# Service Manual

KX-TS80SPW KX-TS85ALW  
 KX-TS85EXW KX-TS85GB  
 KX-TS85GW KX-TS85SPW

**Supplement-1**

**This supplement has been issued for change the part No. of ROM and Electrical parts and Accessories.**

■ ACCESSORIES AND PACKING MATERIALS (Change from original page 7)

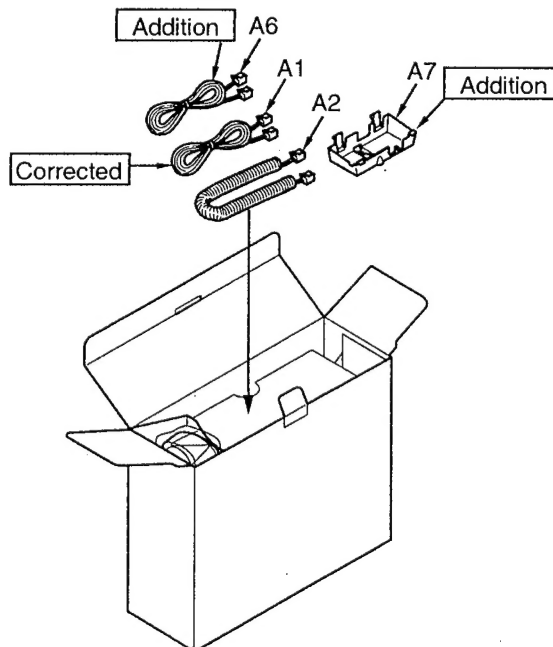
Ref. A1(shape of the plug) has been corrected from the original Service Manual.
